**Re: Letter of Notification of Duquesne Light Company for Approval to Reconfigure Existing and Construct New 138 kV Transmission Lines in Allegheny County, Pennsylvania
Docket No. A-2018-3002896**

**Bureau of Technical Utility Services
Data Requests to Duquesne Light Company**

Docket No. A-2018-3002896

PROJECT PHASE PROGRESSION Phase III

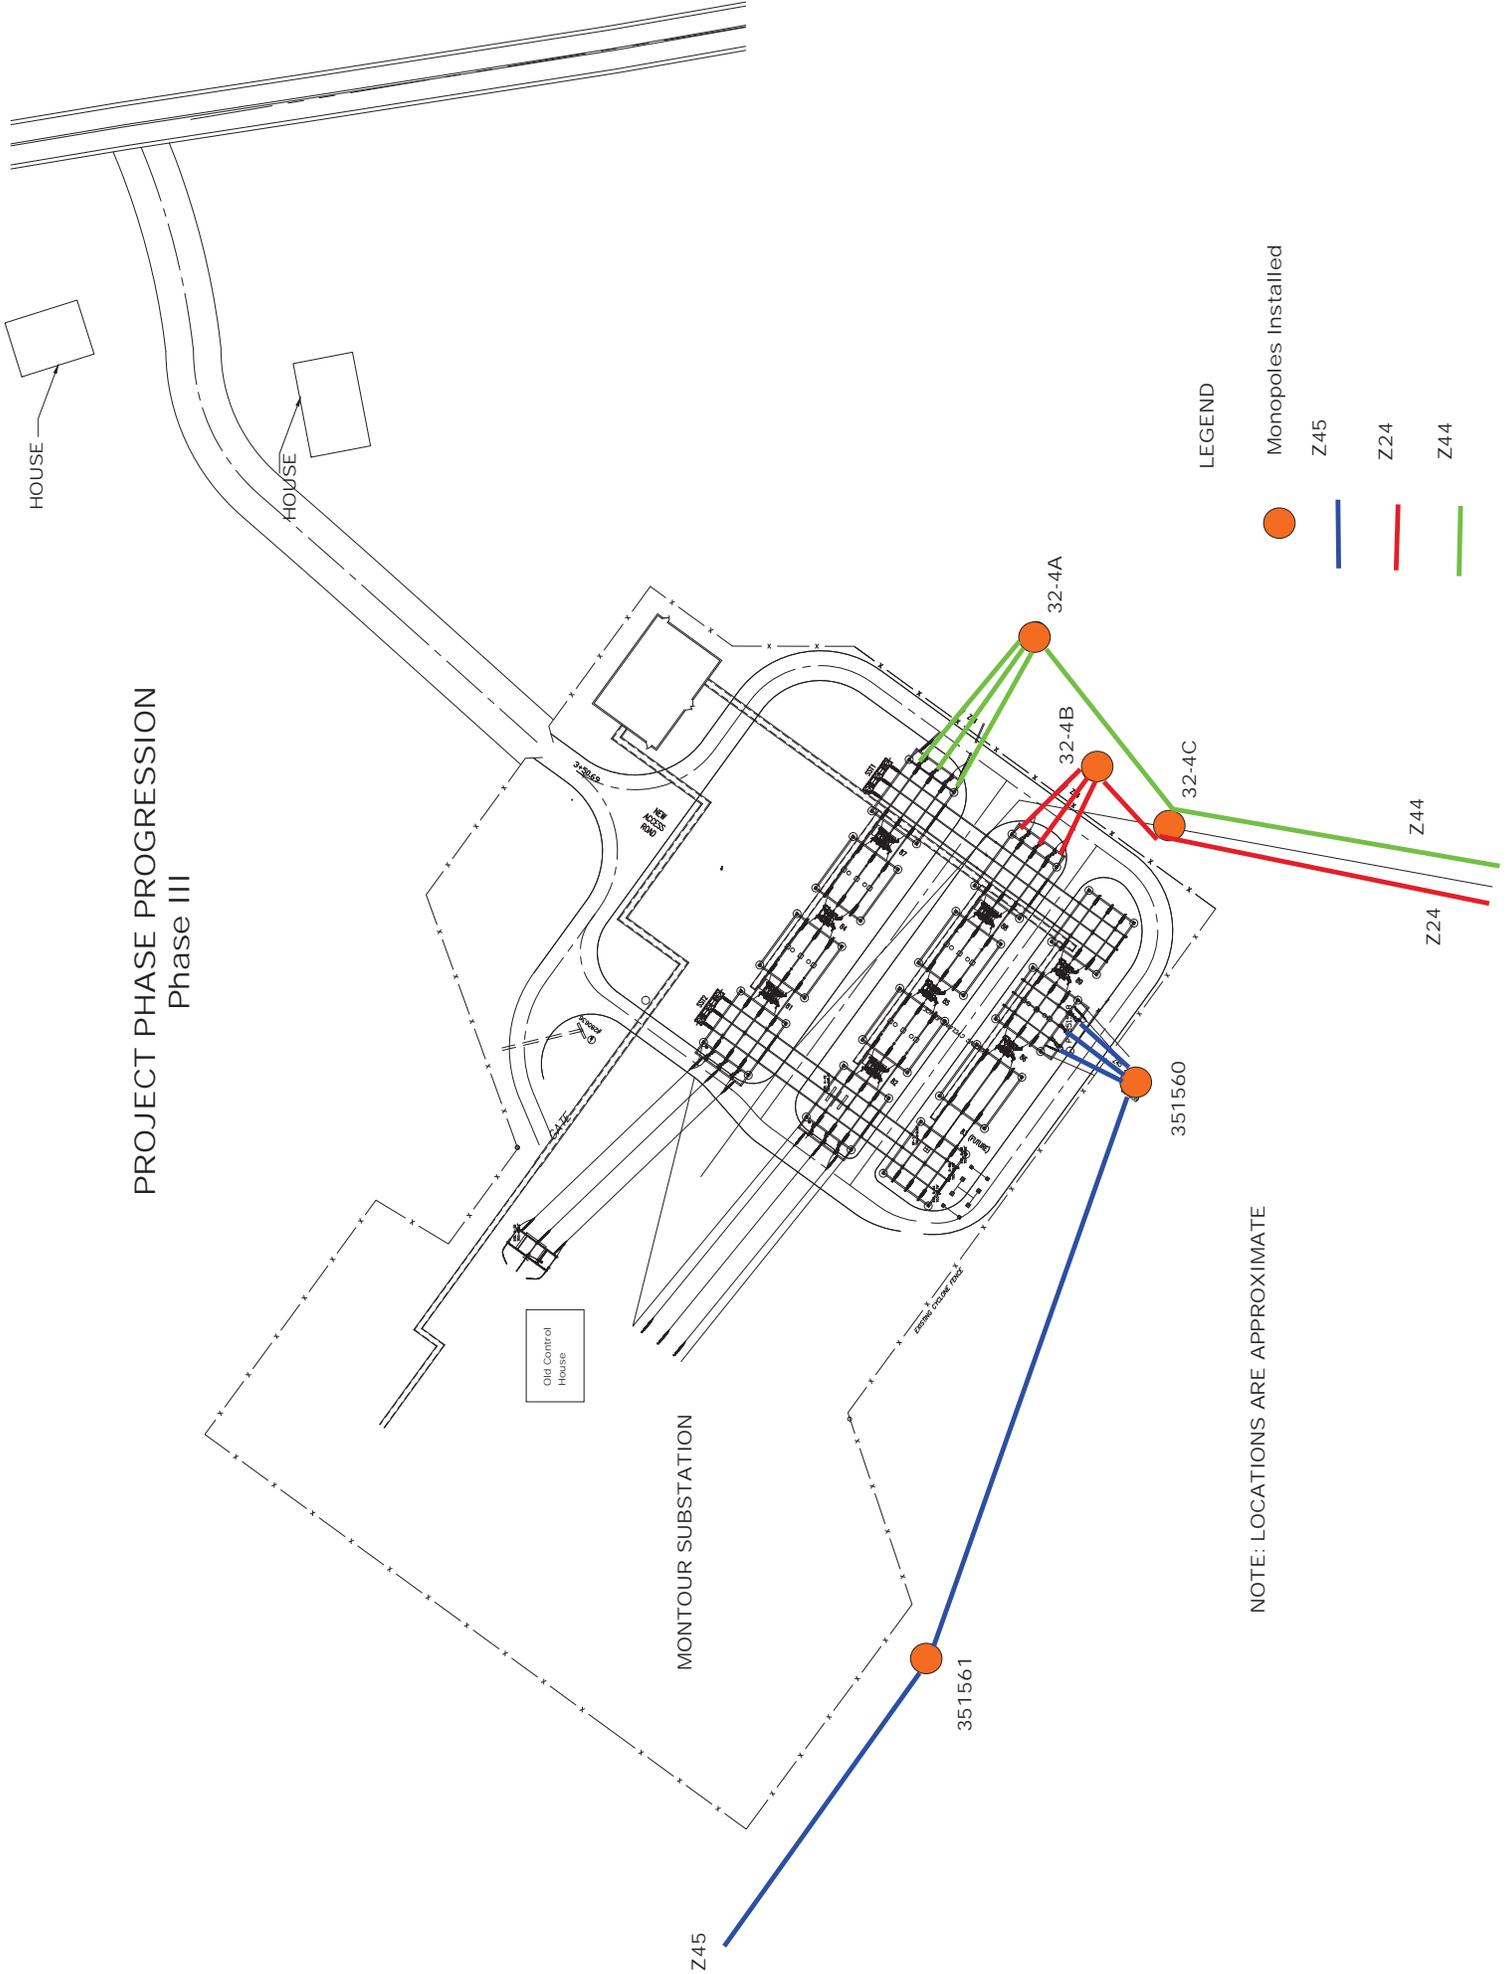
A-6 Reference the Letter of Notification, Section III(B). Please state the height of the new temporary and permanent transmission line structures to be installed.

The following permanent transmission line structures will be installed as part of the proposed project. Included in this response is a revised Attachment 4, which corrects a typographical error that inadvertently omitted the “5” from the “351560” permanent monopole.

Permanent Transmission Line Monopoles	Proposed Height of Monopoles
351560 New	75 ft
351561 New	80 ft
32-4A New	70 ft
32-4B New	80 ft
32-4C New	95 ft

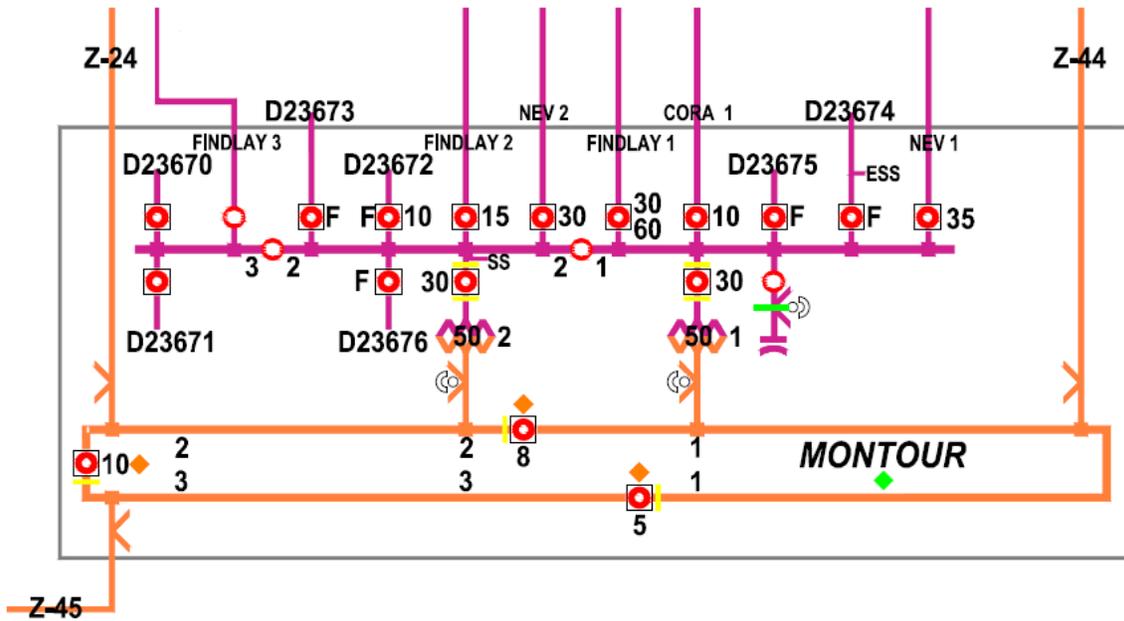
A-9 Reference the Letter of Notification, Paragraph 19 and Attachment 1. Please state the number outages which have occurred in the past 5 years on the three distribution lines fed by the existing ring-bus. Additionally, please state the number of outages which would have mitigated by the proposed breaker and a half configuration.

Montour is sourced by three (3) transmission lines and has two (2) 138-23 kV transformers with three (3) 23 kV busses with a total of seven (7) 23 kV distribution circuits and six (6) 23 kV sub-transmission circuits.

Over the past five (5) years, the Crescent-Montour (Z-24) 138 kV transmission line had a total of twenty-five (25) operations, including planned outages. Of these twenty-five (25) operations, three (3) were unplanned and resulted in the loss of the No. 2 23 kV transformer. During the same time period, the Brunot Island-Montour (Z-44) 138 kV transmission line had a total of forty-one (41) operations, of which two (2) were unplanned and resulted in the loss of the No. 1 23 kV transformer.

On March 31, 2018, the No. 1 138-23 kV transformer was out of service for replacement due to failure. A landslide occurred along the Crescent-Montour (Z-24) 138 kV transmission line which resulted in the operation of two (2) 138 kV tie breakers at Montour and the loss of the No. 2 138-23 kV transformer. With no 138-23 kV transformers in service at Montour, three (3) Findlay-Montour 23 kV sub-transmission lines started to overload even during the early morning on hours on a Saturday which is a lighter load period. Duquesne Light's Operations Center was able to remotely transfer load on its 23 kV distribution circuits to prevent further overloads of the 23 kV sub-transmission lines as well as prevent customer outages. However, had this event occurred during a higher load period, customers could have been directly impacted. The planned breaker and half configuration at Montour would have prevented this transmission line operation from causing an outage to any of the Montour 138-23 kV transformers.
